**Planning and Zoning Commission - Regular Meeting AGENDA**

Tuesday, August 11, 2020 at 4:30 PM  
Ketchum City Hall  
480 East Avenue North, Ketchum, ID 83340

- 5. ACTION - Fourth and Walnut Mixed-Use Building Design Review:** (Project Location: Ketchum Townsite: Block 44: Lots 7 and 8, 371 and 391 N Walnut Avenue) The Commission will consider and take action on a Design Review Application submitted by Graham Whipple of Resin Architecture for a new 20,876 square-foot, two-story mixed-use building and associated site

**2** NE Elevation (Walnut)  
SCALE: 1/8" = 1'-0"

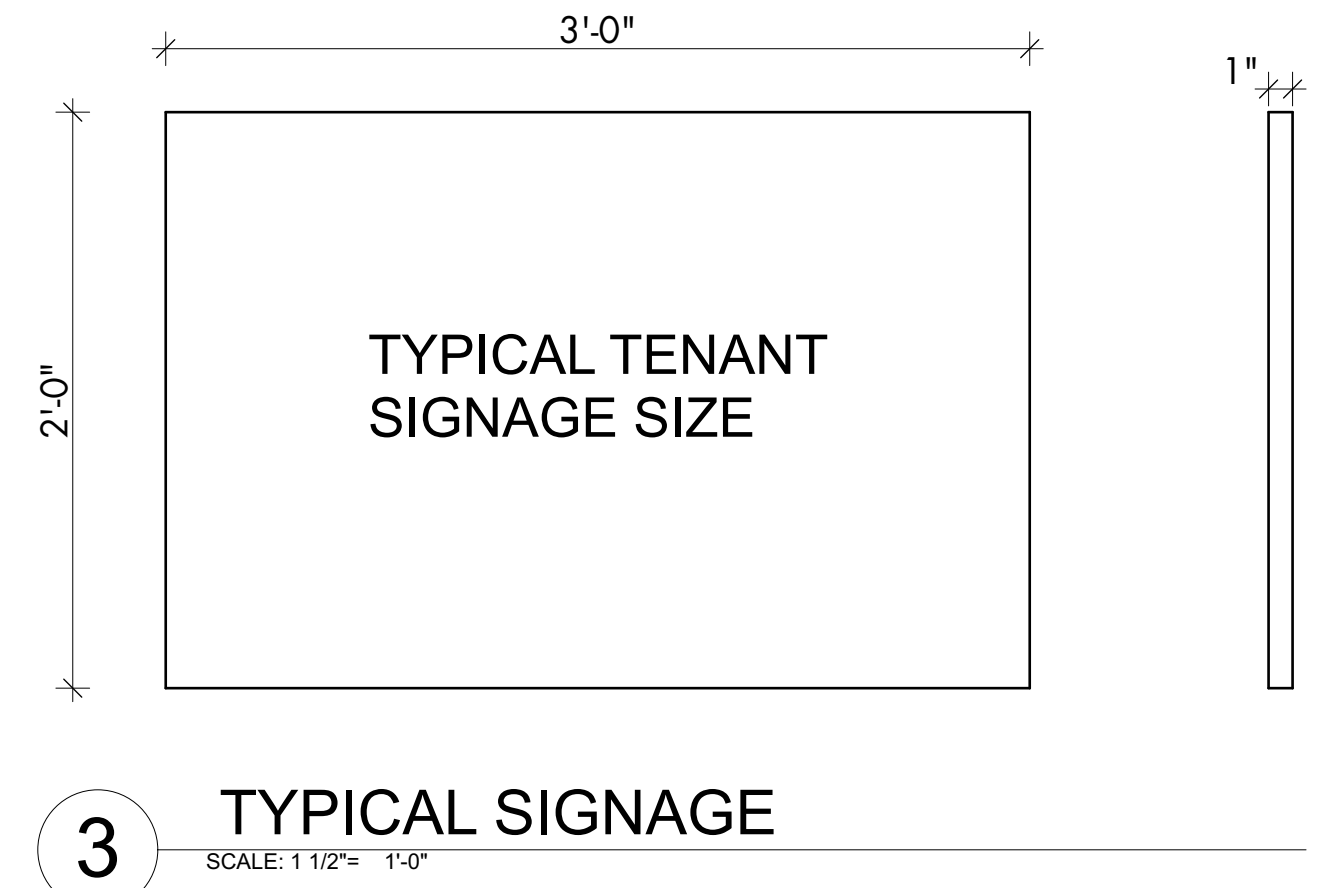
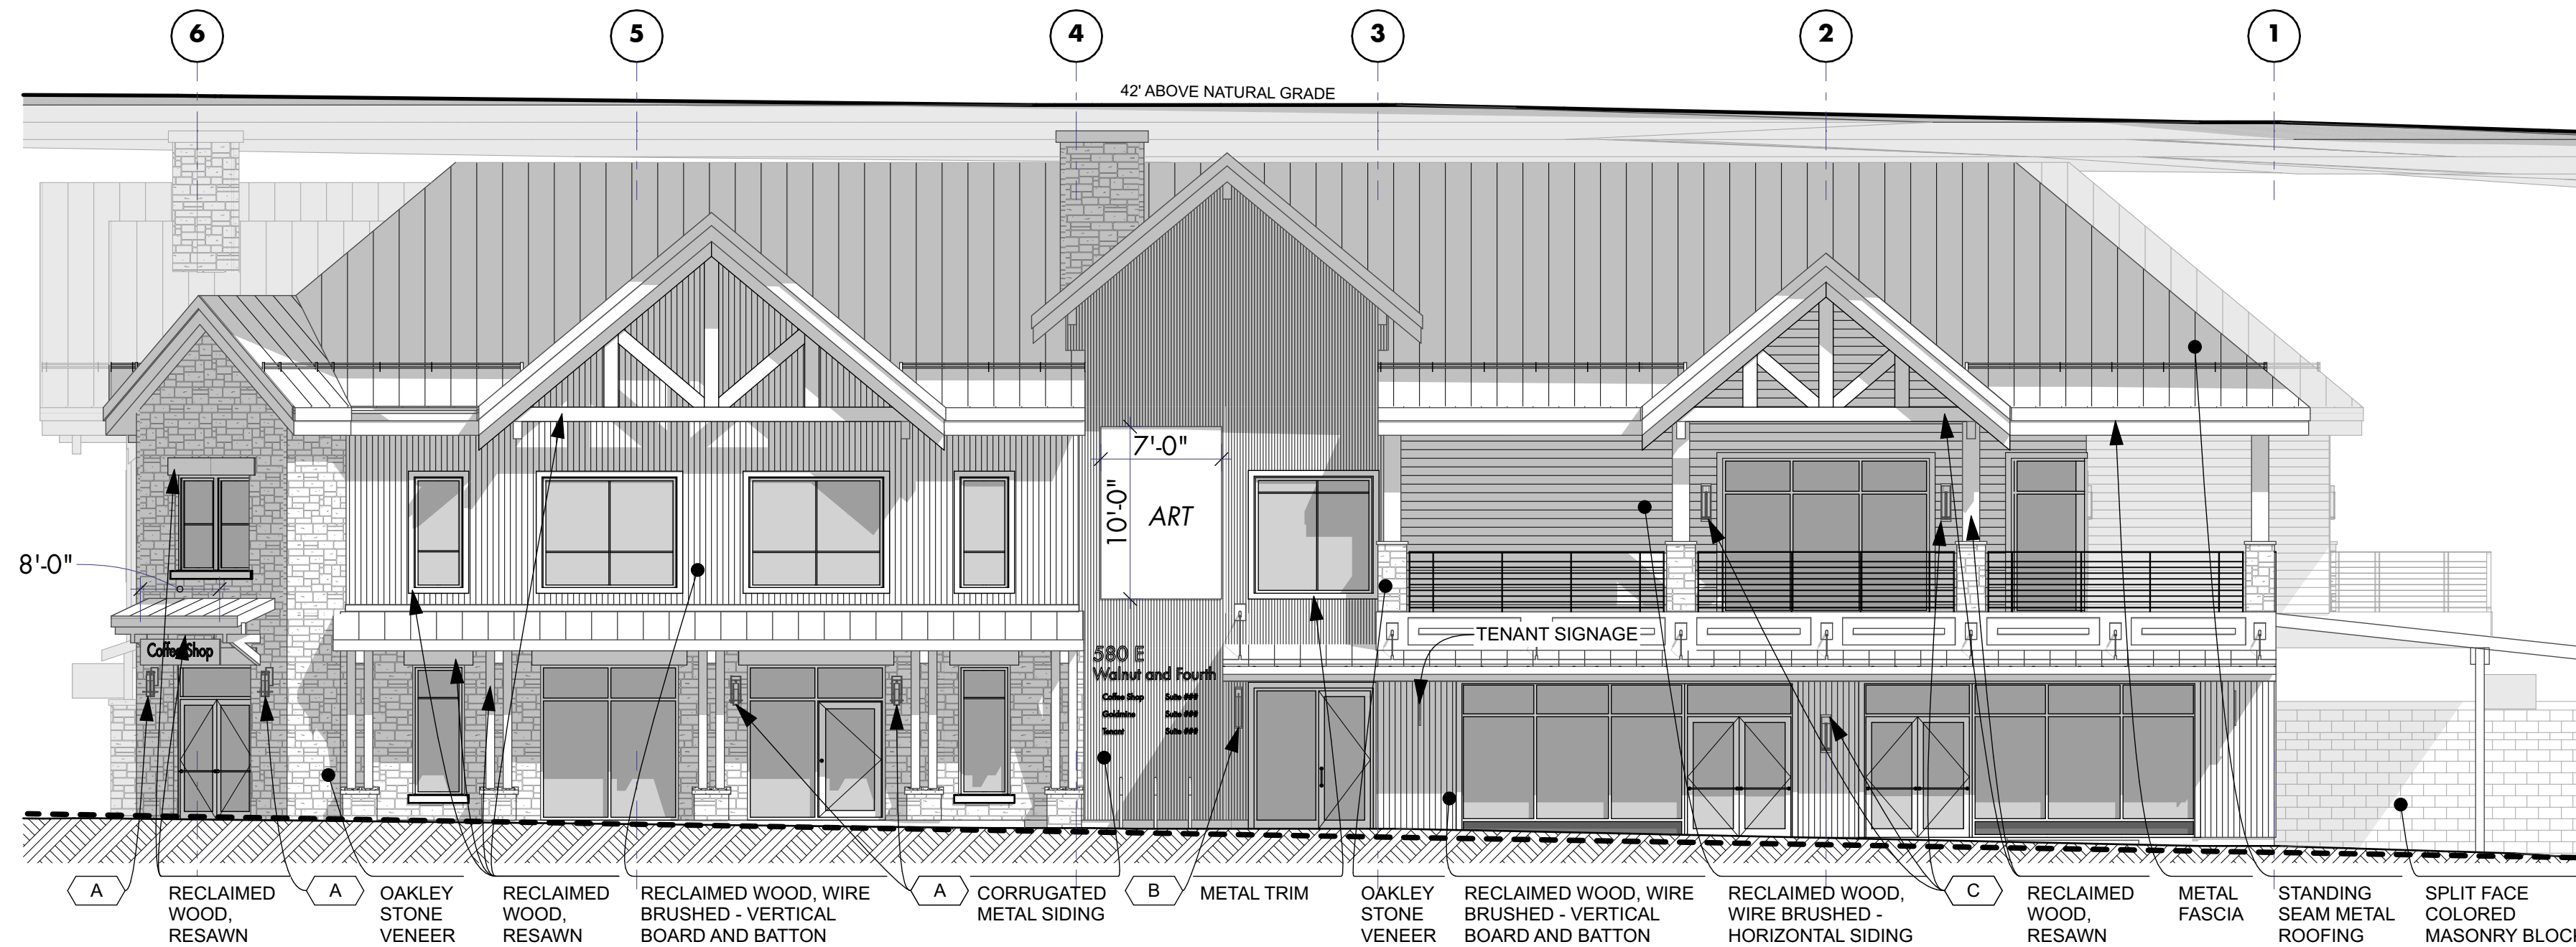
The applicant has annotated the elevations (Sheets A-201 & A-202) to specify the proposed exterior materials. The applicant has included additional renderings in the updated project plans. A link to a video illustrating the project from all elevations is attached to the Staff Report as Exhibit B.

**1** SE Elevation  
SCALE: 1/8" = 1'-0"

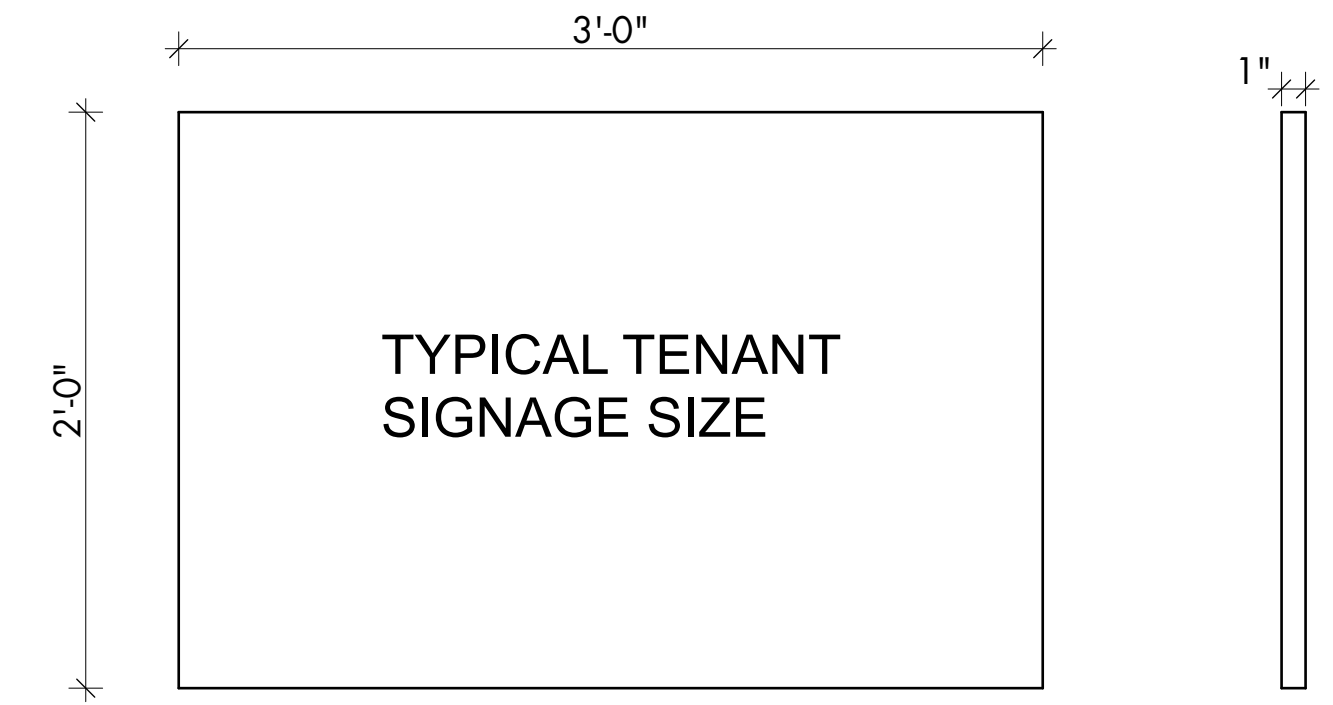
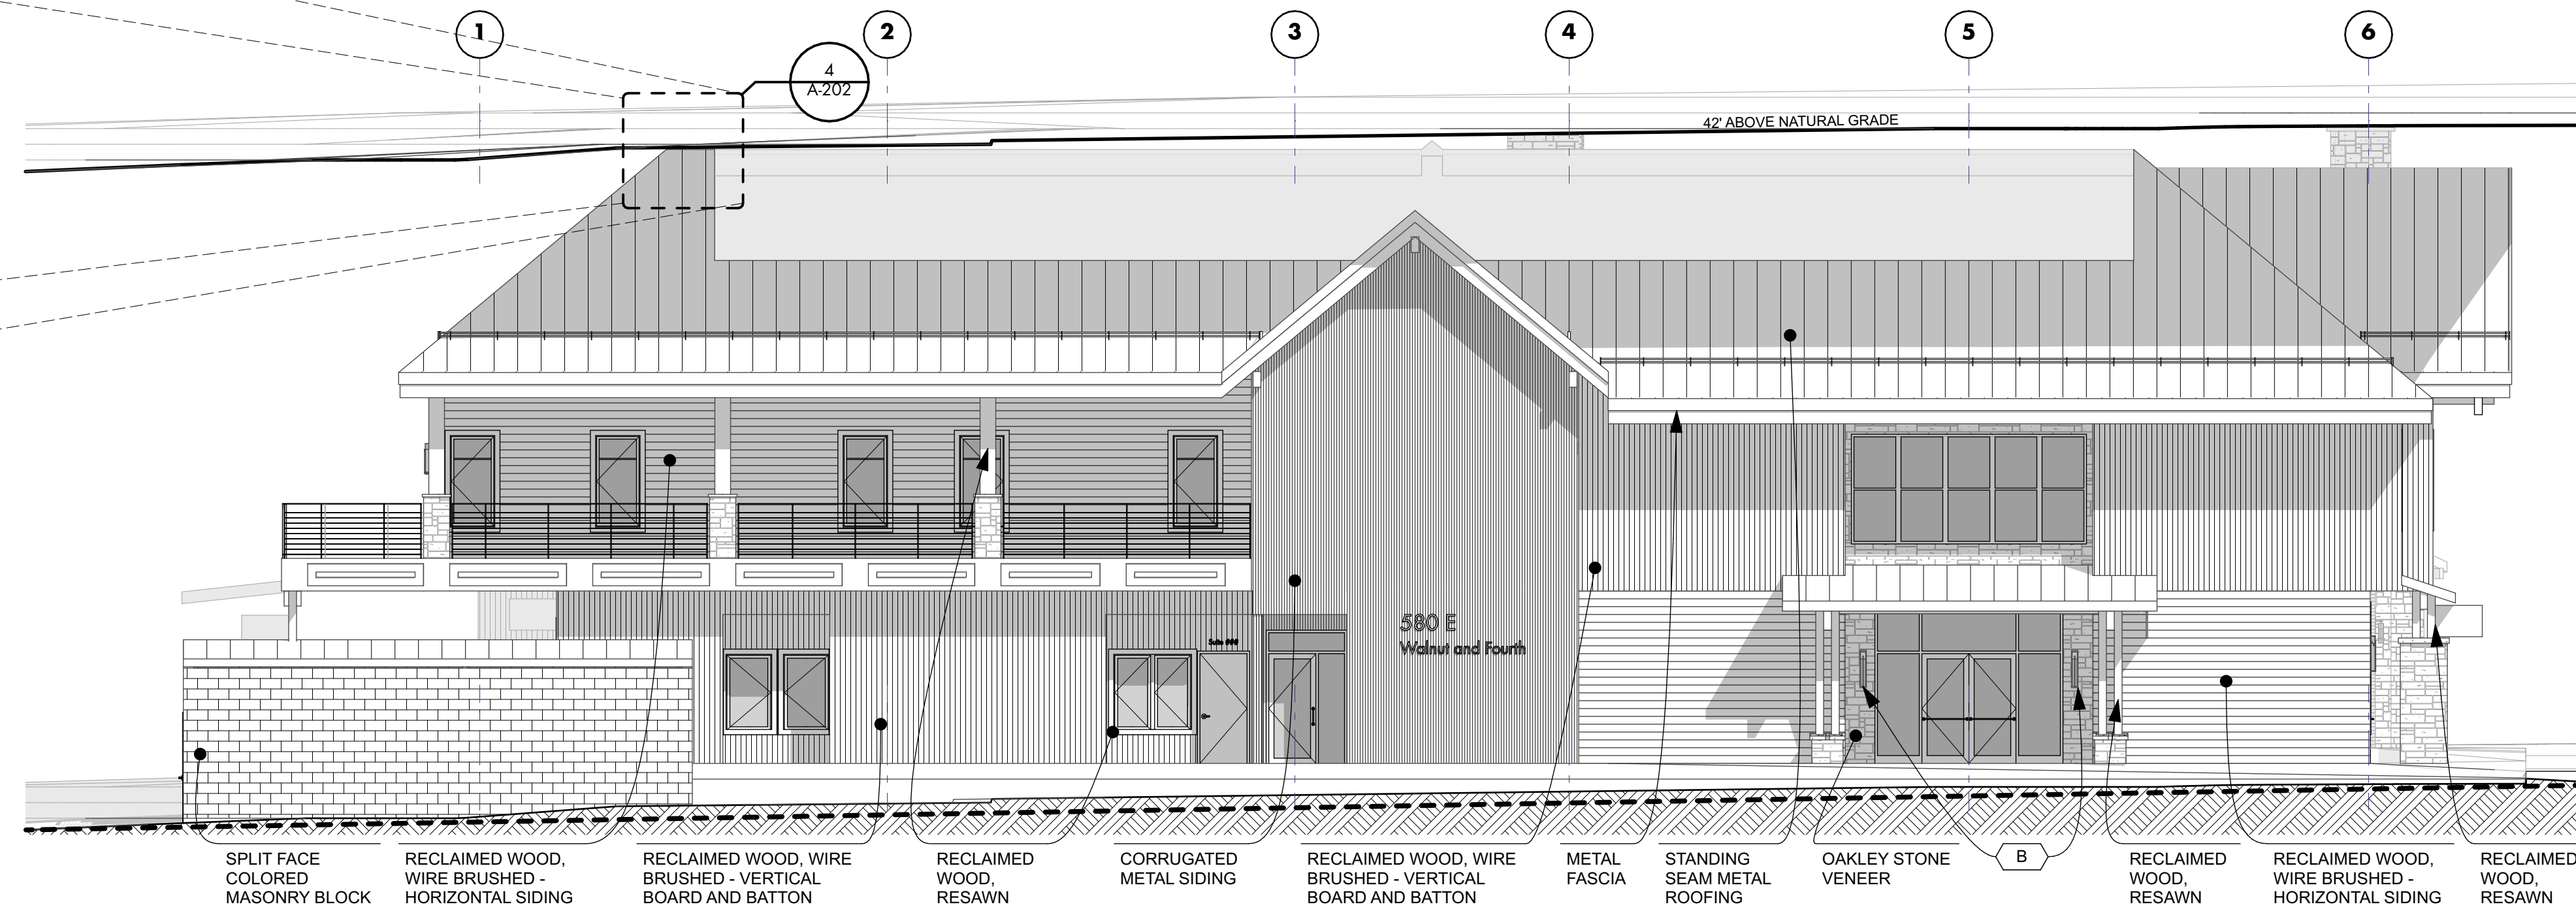
Staff Comments	<i>The proposed roof is a false mansard. As illustrated on the southeast elevation indicated on Sheet A-202, the top of the mansard roof falls into a 10-foot deep recessed area that is fully screened from public view. All roof-mounted mechanical, plumbing, and electrical</i>

Figure 3: Exterior Lighting Fixtures, Project Plans

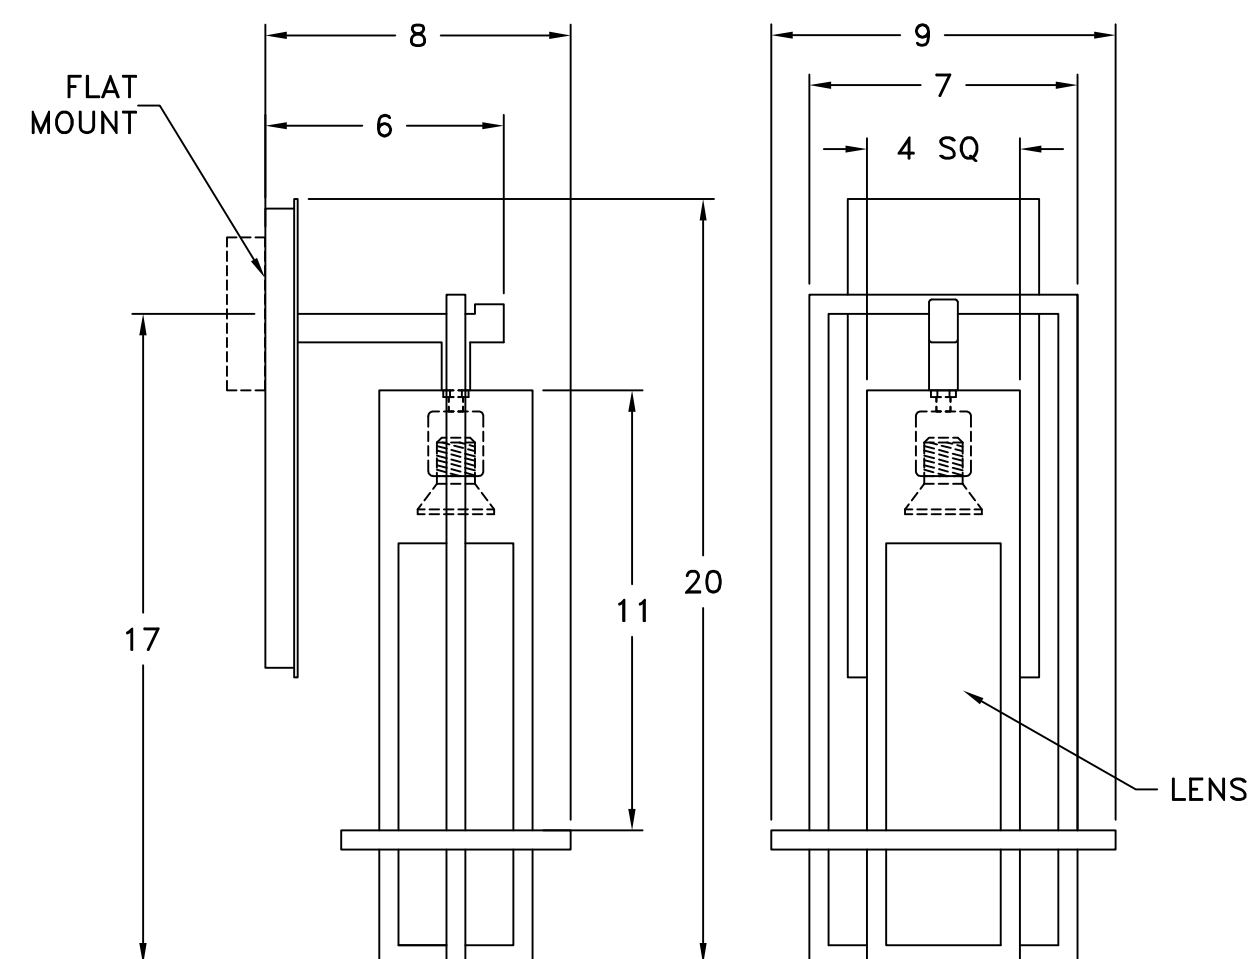
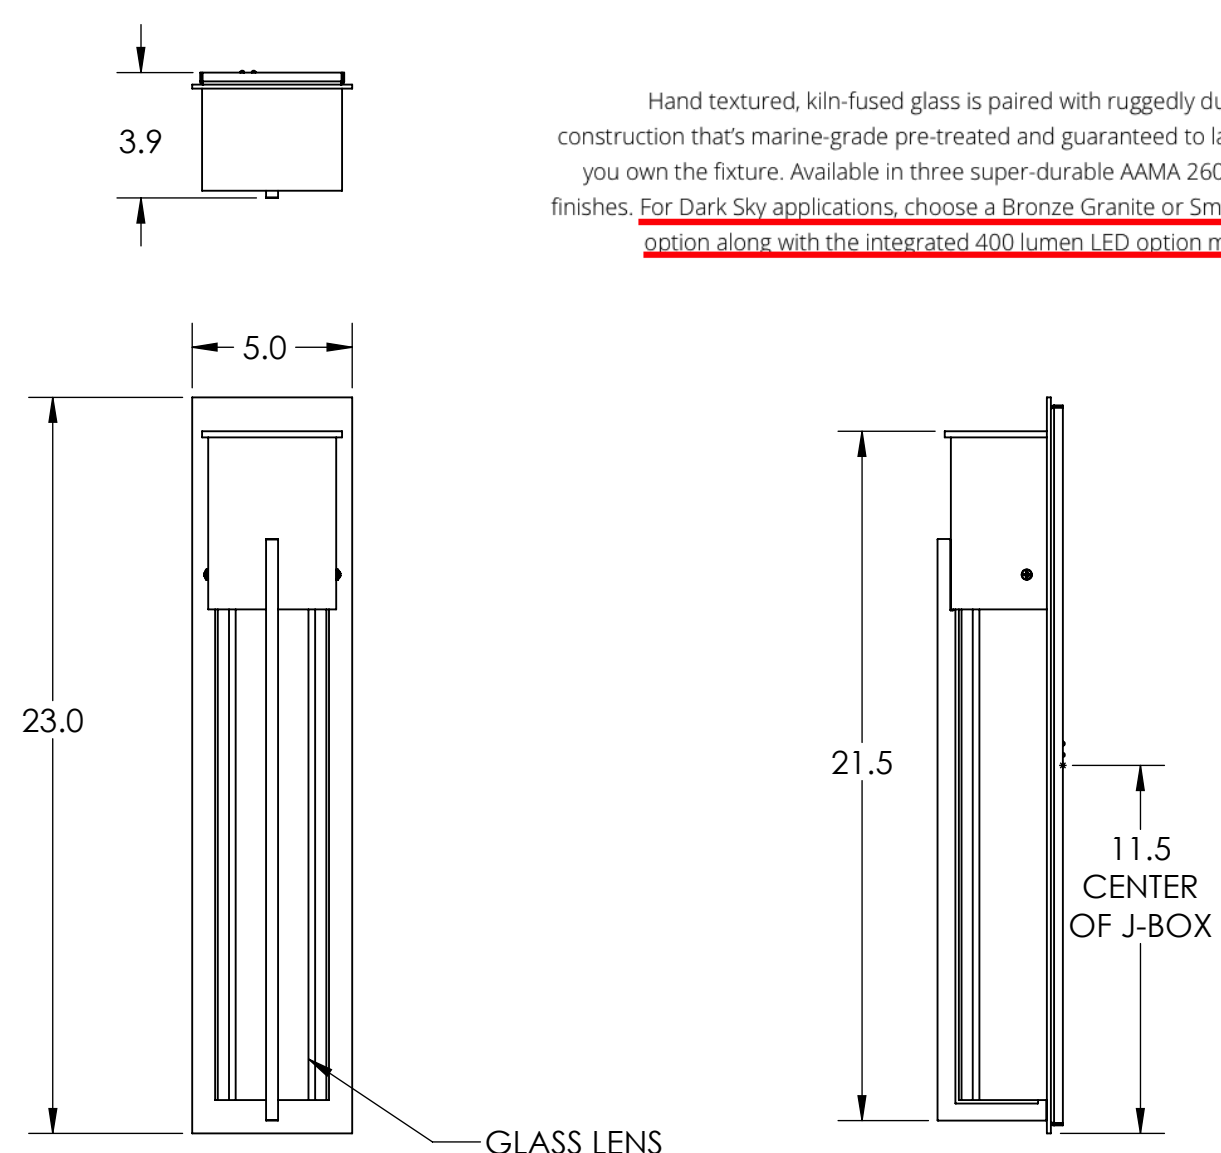
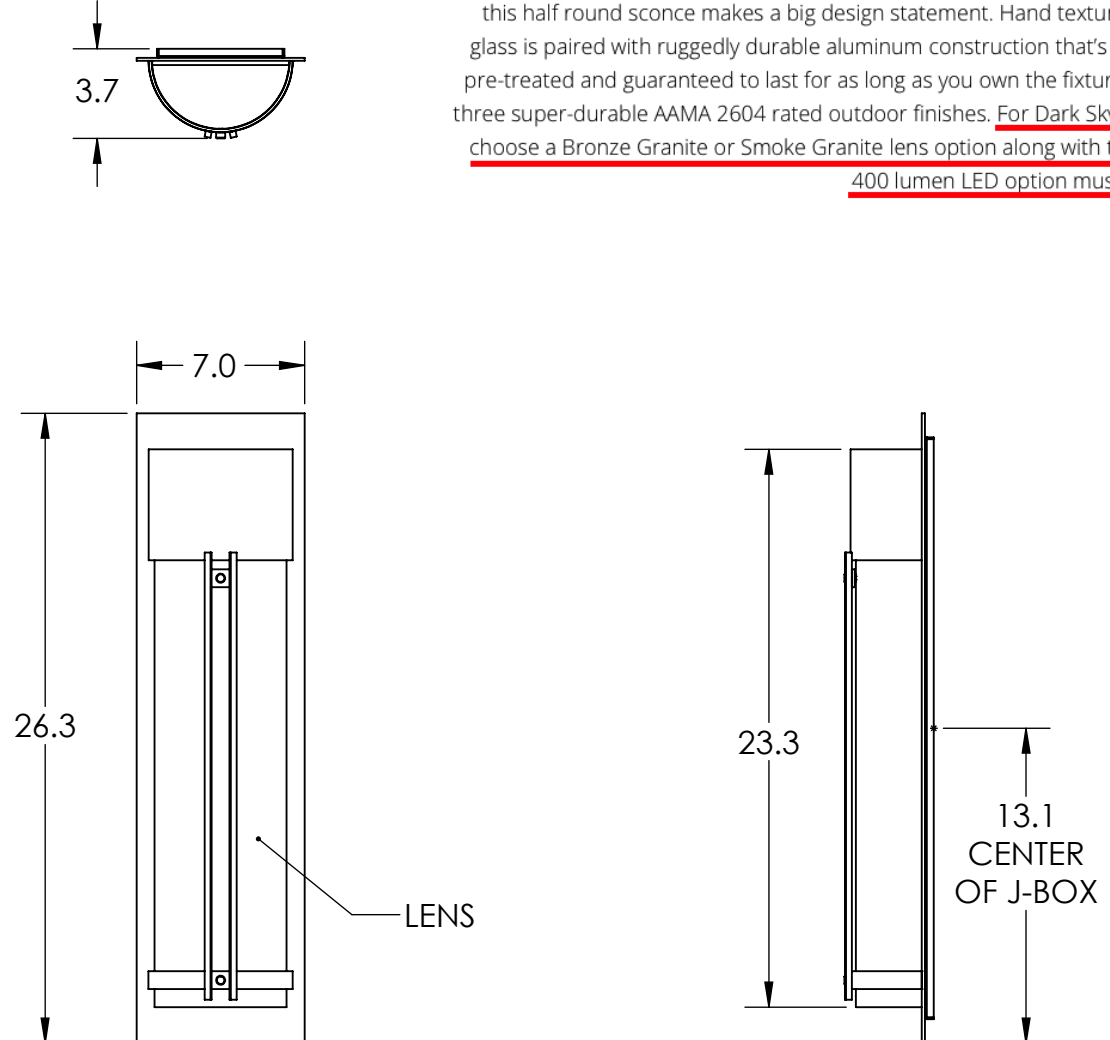
The applicant has provided specifications for the proposed exterior lighting fixtures on Sheet AF-102 of the updated project plans. The lighting plan proposes four types of fixtures—three fully shielded wall sconces and one recessed can light. The first and second floor plans (Sheets A-101 & A-102) show the proposed locations of the four types of fixtures. The wall sconces frame the entrances to the retail spaces and the coffee shop. The lighting enhances safety for pedestrians entering and exiting the mixed-use building. The proposed exterior lighting is Dark Sky compliant as the fixtures shield the light bulbs to minimize glare and light trespass (KMC 17.132.030.H).
